Development Management Planning Application Consultation – Urban Design Comments

Ref: DC/21/01110/RM

Location: Phase 2B, Land at NW Haverhill, Ann Suckling Road, Little Wratting

Figure 2 – Neighbourhood Square

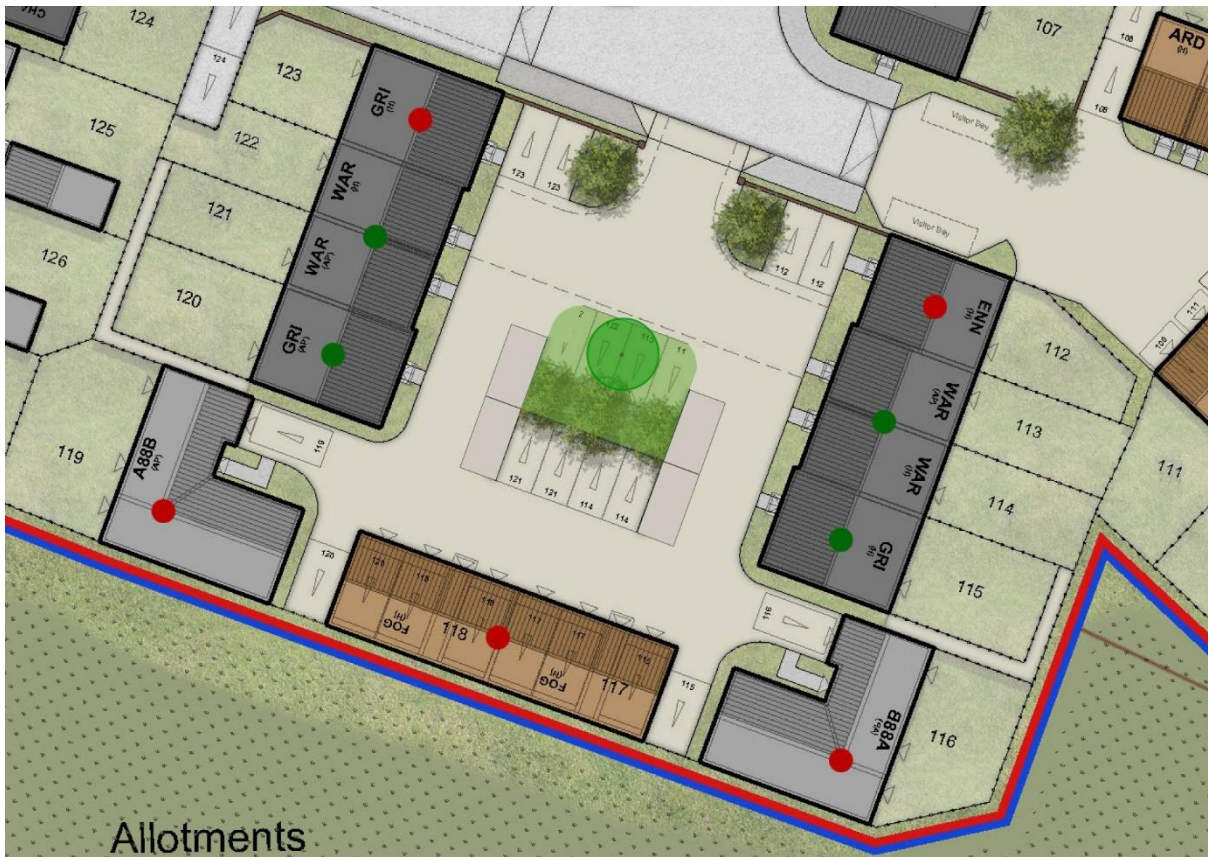
Within the courtyard spaces, the flats over garages (FOGs) help to animate these spaces, provide natural surveillance and the courtyard spaces help to create a more permeable development. In terms of the revised design for the Neighbourhood Square, the view of the square from The Avenue terminates with a row of parking bays and it is recommended that this is reviewed to create a more attractive vista stop (please see suggestion in Figure 2 below).
